***PROTECTION OF PRIMARY FIXED-SATELLITE SERVICE FROM  
PROPOSED SECONDARY AIR-GROUND MOBILE SERVICES  
IN 14.0-14.5 GHz***

November 14, 2013

***Note: This presentation is intended to be read in conjunction with the Satellite Industry Association's comments, reply comments and ex parte presentation submitted in GN Docket 13-114 and RM-11640.***

## SES-2 G/T Map

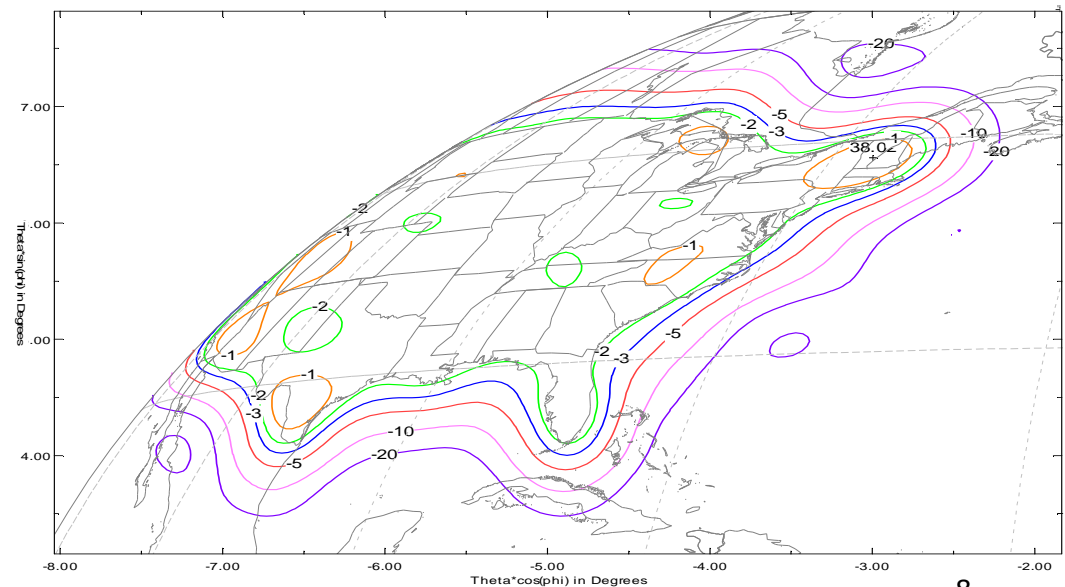
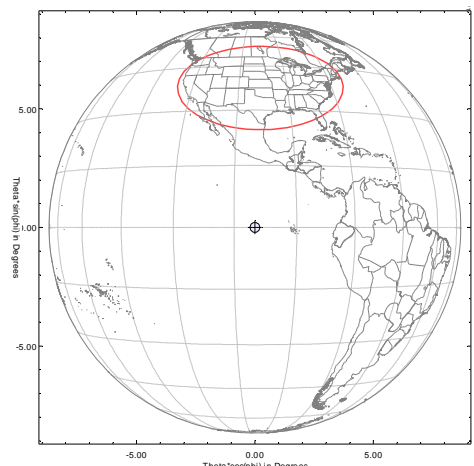
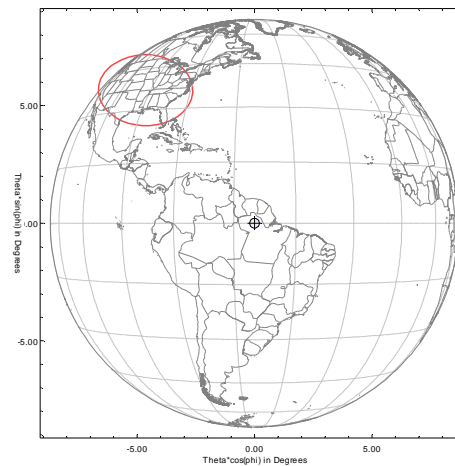
Peak G/T = 7.99 dB/K

Edge of CONUS G/T = 4 dB/K

Average G/T = 6 dB/K

**The G/T for SES-2 is greater than 4 dB/K  
for nearly all of CONUS**

## SATELLITE VIEW FROM 40°W:

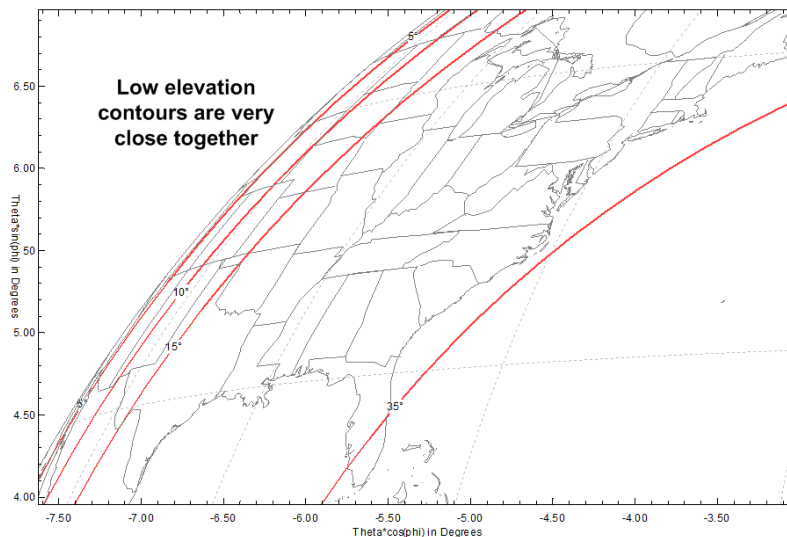
- Qualcomm asserts that low elevation aircraft should not cause interference to a CONUS beam from 40°W because the GSO cannot provide service at such low elevation angles

- But the low elevation directions are very close to the main service area of the GSO and so will inevitably have high satellite gain towards them
- Therefore must take account of low elevation interference

Qualcomm did not “consider satellites that are positioned at the far east ... of CONUS”  
Qualcomm did not “analyze the worst case scenarios”

# NGSO Satellite Beam with +3 dB/K G/T Pointed Towards 15° Elevation Location

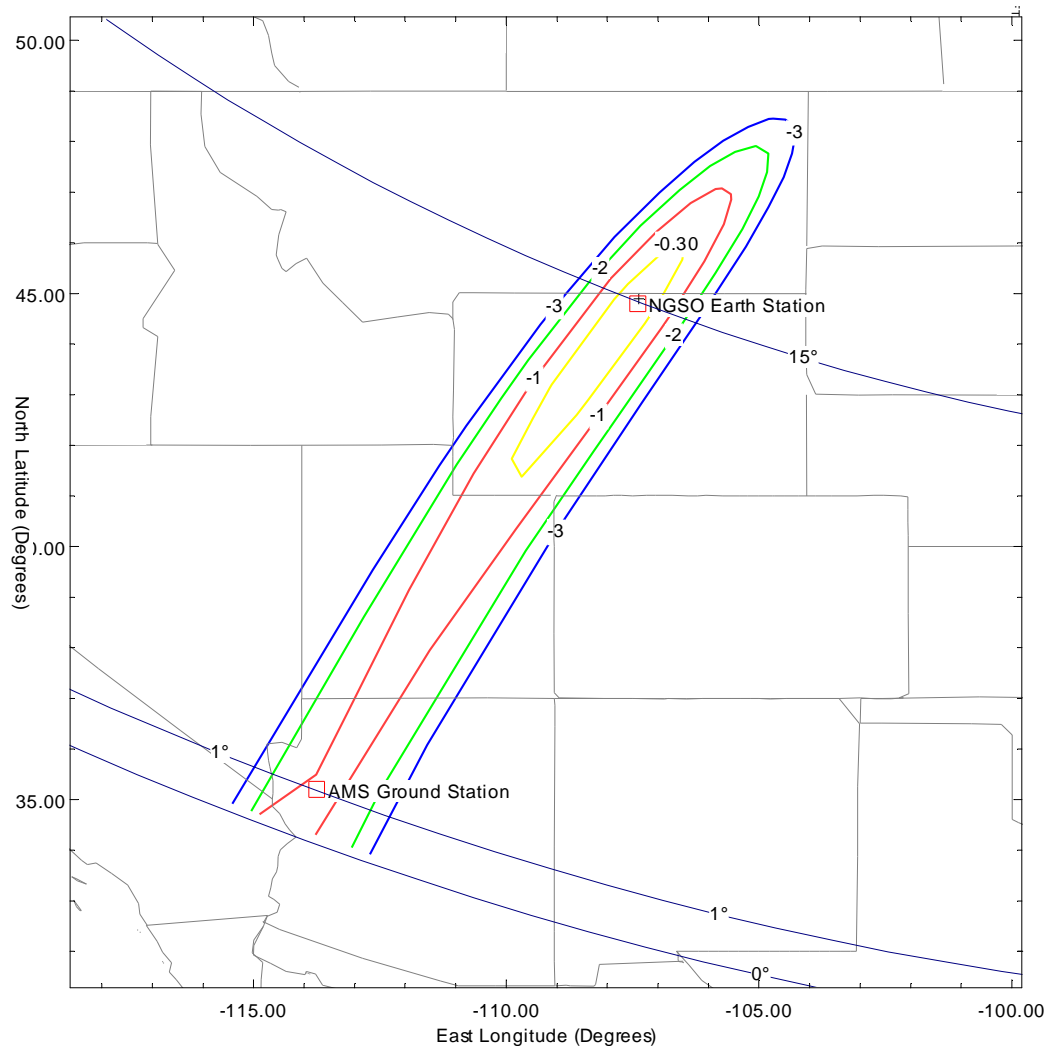
1. For SIA Case C, beam peak is pointed towards **15°** elevation earth location.  
*(Not at 1° elevation as stated by Qualcomm)*
2. Resulting from 1. above the NGSO satellite receive beam roll-off towards the AMS GS is **-1 dB**.  
*(see next chart to support this)*
3. Resulting  $\Delta T/T$  is **215.05%**.

1. For Qualcomm analysis involving NGSO peak G/T = +3 dB/K, in order to get the results it wants, Qualcomm assumes the NGSO system is incapable of providing service at less than **20°** elevation.
2. Resulting from 1. above the NGSO satellite receive beam roll-off towards the ATG GS is **-16 dB**.
3. Resulting  $\Delta T/T$  is **3.3%**.

- Beam plot shows a +30 dBi peak gain receive beam
- Equivalent to peak  $G/T = +3$  dB/K assuming  $T = 500K$
- Boresight (shown by a +) directed towards a transmitting earth station located on 15° elevation contour
- Results in -1 dB relative gain contour intersecting the 1° elevation contour

# AMS Aircraft Terminal Issues

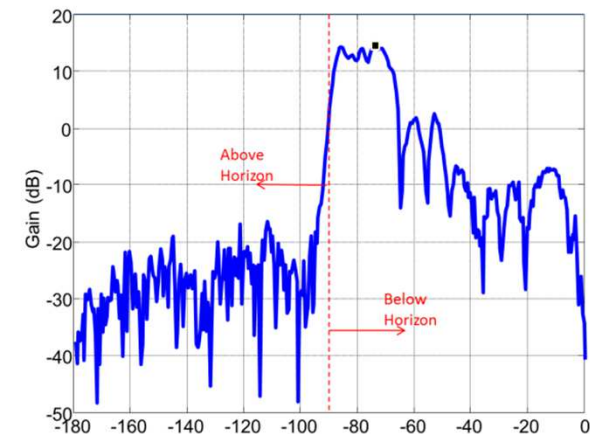
- Qualcomm's aircraft antenna performance has evolved over time
  - Qualcomm's latest aircraft antenna pattern is being reviewed
  - We note that the latest prototype does not seem to be the blade antenna originally proposed by Qualcomm → → → → →
  - Variation in antenna designs underscores the need for verifiable antenna performance standards, not just aggregate limits

- Latest aircraft antenna design has exceedingly steep gain-roll off in elevation plane (> 5 dB per degree) → → → → → → → → → →
  - Unclear if "Horizon" gain at 90 degrees elevation is actually the "Horizontal" gain, such that "Below Horizon" actually means "Below Horizontal" but which may still be above the actual horizon as viewed from aircraft
  - This is important because aircraft typically have a "nose up" attitude during flight
  - Increased risk of interference to FSS if:
    - Antenna performance is impacted by fuselage or other physical attributes of aircraft
    - Installation tolerances
